Access Compliance Report

Public Rights-of-Way

(Curb Ramps)

Intersection ID: 12671	Main Street: SEIGLE_AV	Cross Street: GREENWAY_CRESCENT_LN	Location: NW
ADA ID: 1A4BD1679C99	Ramp Type: Directional1	Initial Pass/Fail: Fail	Overall Compliance: No
Severity Score: 1.25			
Codes/Mitigation Info/Possible Solution		Field Measurements/Component Compliance

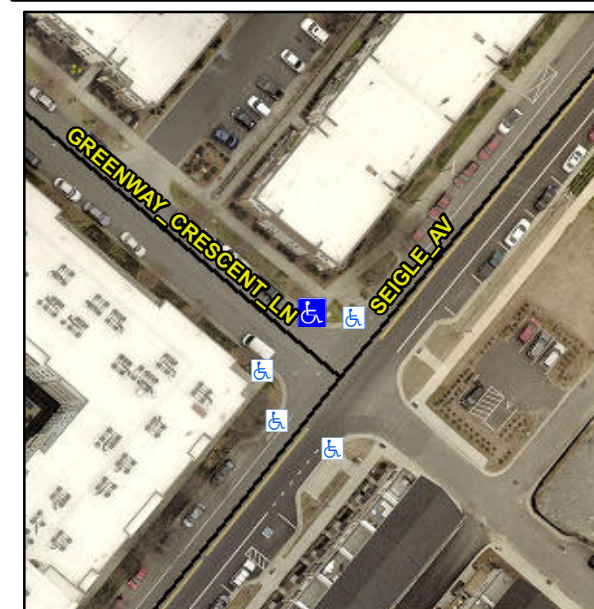
R304.5.3

Compliance	Description	Data	Compliance	Description	Data
N/A	Ramp Length (in)	95.5	N/A	Grade Break?	N/A
Yes	Ramp Width (in)	70.0	N/A	Grade Break Slope (%)	0.0
Yes	Ramp Slope (%)	6.8	N/A	Grade Break XSlope (%)	0.0
No	Ramp XSlope (%)	4.6			
N/A	Flare Type LT	N/A	N/A	Flare Type RT	N/A
N/A	Flare Slope LT (%)	N/A	N/A	Flare Slope RT (%)	0.0
N/A	Flare Traversable LT?	N/A	N/A	Flare Traversable RT?	N/A
N/A	Landing Length (in)	0.0	N/A	DWS Provided?	N/A
N/A	Landing Width (in)	0.0	N/A	DWS Contrast?	N/A
N/A	Landing Slope (%)	0.0	N/A	DWS Length (in)	N/A
N/A	Landing X Slope (%)	0.0	N/A	DWS Full Width?	N/A
N/A	Landing Curb? (Y/N)	N/A	N/A	DWS Offset LT (in)	N/A
N/A	Shared Landing?	N/A	N/A	DWS Offset RT (in)	N/A
N/A	Gutter Ponding?	0.0	N/A	Gutter Slope (%)	N/A
N/A	Gutter Lip Ht (in)	0.0	N/A	Gutter X Slope (%)	N/A
N/A	Painted X Walk1?	No		Road Slope (%)	0.5
	X Walk 1 Direction	To SW		Road X Slope (%)	5.1
	X Walk 1 Width (in)	N/A		Clear Space?	N/A

X Walk 1 Slope (%)	0.5	N/A	Clear Space to XWalk (in)	N/A
	X Walk 1 X Slope (%)	5.1	N/A	Storm Grate/Utility Hazard?	N/A
N/A	Ramp inside XWalk1?	N/A		Storm Grate/Utility Type	
N/A	Any Obstructions?	N/A			N/A
	Obstruction Type		Yes	Surface Condition? (G/P)	Good
			N/A	Curb Slope (%)	10.1

Possible Solutions:

Remove & Replace Entire Ramp.
